Access Compliance Report Public Rights-of-Way (Curb Ramps)

Main Street: HICKORY_BRANCH_RD Cross Street: RAINBOW_DR Location: NW

ADA ID: RPRK220103144255 Ramp Type: Type 4 - Parallel Initial Pass/Fail: Fail Overall Compliance: No Severity Score: 16

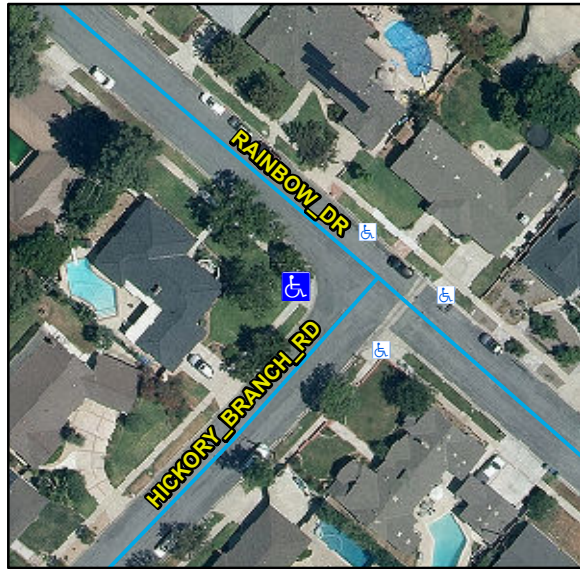
Compliance	Description	Data	Compliance	Description	Data
N/A	Ramp Length LT (in)	134	N/A	Ramp Length RT (in)	120
Yes	Ramp Width LT (in)	92	Yes	Ramp Width RT (in)	94
Yes	Ramp Run Slope LT (%)	4.2	No	Ramp Run Slope RT (%)	9.2
No	Ramp Cross Slope LT (%)	3.6	Yes	Ramp Cross Slope RT (%)	0.8
N/A	Landing Present	N/A	N/A	DWS Provided	N/A
N/A	Landing Length (in)	N/A	N/A	DWS Contrast	N/A
N/A	Landing Width (in)	N/A	N/A	DWS Length (in)	N/A
N/A	Landing Run Slope (%)	N/A	N/A	DWS Full Width	N/A
N/A	Landing Cross Slope (%)	N/A		DWS Offset Type	N/A
N/A	Landing Movement Obstructed?	N/A	N/A	DWS Offset Left (in)	N/A
	Landing Movement Type	N/A	N/A	DWS Offset Right (in)	N/A
N/A	Landing Shared	N/A			
N/A	Clear Space	Yes			
N/A	Clear Space To Crosswalk (in)	N/A			
N/A	Marked Crosswalk 1	No	N/A	Marked Crosswalk 2	No
	Crossing 1 Direction	SE		Crossing 2 Direction	NE
	Marked Crosswalk 1 Width (in)	N/A		Marked Crosswalk 2 Width (in)	N/A

Remove & Replace Curb Ramp With Two New Directional Ramps or Equivalent.
